Product Change Notice: EV Series and EP Series Relays

PCN.PGB0005A0004.10.30.2018

10.30.2018

■ EV relays and EP relays 20A

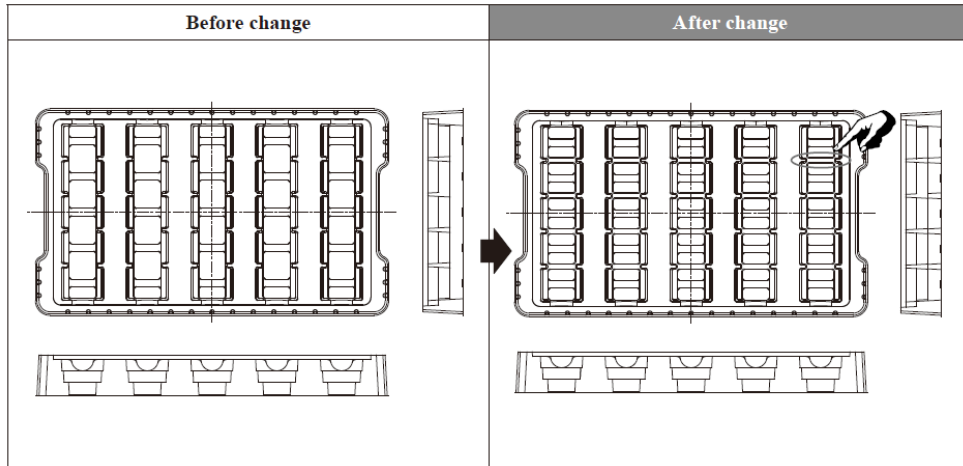
1. Added ribs on the bottom of relay storage tray (Total 20 places)
